**3-G-21-HZ**  
**APPLICATION FOR CERTIFICATE OF APPROPRIATENESS**

1121 Eleanor St. 37917  
 \_\_\_\_\_  
 Fourth and Gill H

Original Print Date: 3/9/2021  
 Knoxville/Knox County Planning -- Historic Zoning Commission

**Meeting:** 3/18/2021  
**Applicant:** Sean and Sara Martin  
**Owner:** Sean and Sara Martin

**PROPOSED BACK ELEVATION (WEST)**

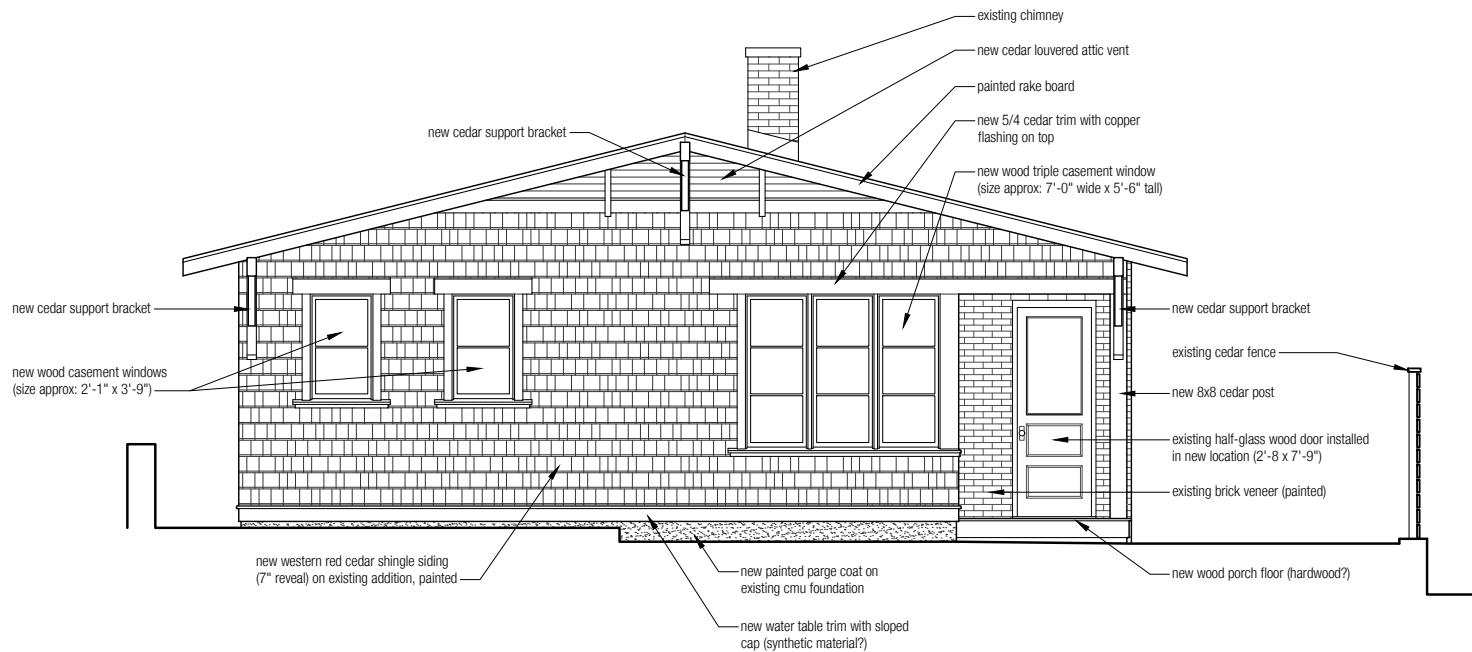
3. All other work is proposed for a non-historic addition on the house's rear, constructed in 2006. Overall, the revised design will be compatible but differentiated from the original section of the house. New details will connect the addition with the house's Craftsman design, including cedar support brackets, a triangular wood louvered vent, and cedar trim.

4. The rear addition, previously clad in fiber cement lap siding, will receive new shingle siding - cedar, Hardie, and LP Smartside composite with 7" exposure are all included in the proposal for discussion. In staff's opinion, any of the three proposed materials would be appropriate, as work will occur on a non-historic addition which is not visible from the public right-of-way. Cedar shingles meet the design guidelines most directly; however, the existing addition currently has fiber cement lap siding and any of the three materials will sufficiently differentiate the addition from the main house's brick exterior, while not detracting from the house's historic character.

6. The addition also includes new windows, including two, two-light wood casement windows on the left side and one wood triple casement window (approximately 7'-0" tall wide and 5'-6" tall) on the right. The proposed windows

are compatible with the overall design of the house. The applicant has included for discussion the possibility of using Marvin "Elevate" brand windows (paintable fiberglass composite material) in the same dimensions and design as the submitted drawing. The composite windows would be limited to the rear addition, not visible from the street, which is a west-facing elevation that receives significant sun and weather impact through the year.

Staff recommends approval of the work as submitted.

**PROPOSED SIDE ELEVATION (SOUTH)**

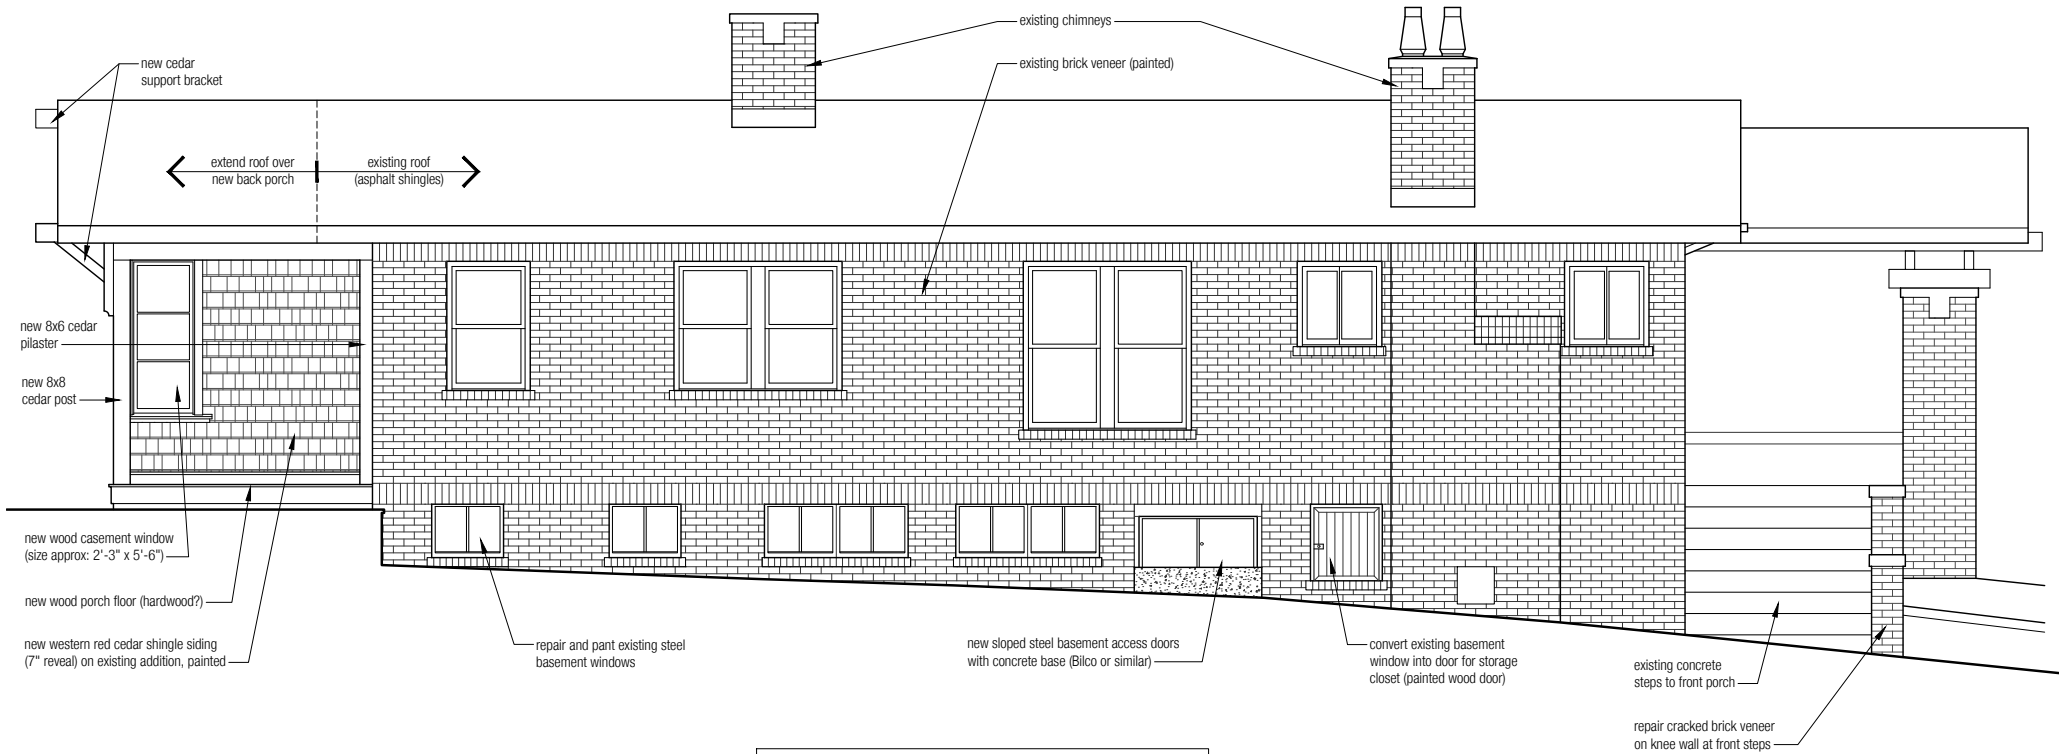
1. 1121 Eleanor Street is a contributing resource to the Fourth and Gill National Register Historic District and local historic overlay.
2. The installation of sloped steel basement access doors on the south side elevation will not affect any significant historic features and will be very minimally visible from the street, if visible at all. The basement access doors could be removed without affect on the house's character-defining features.
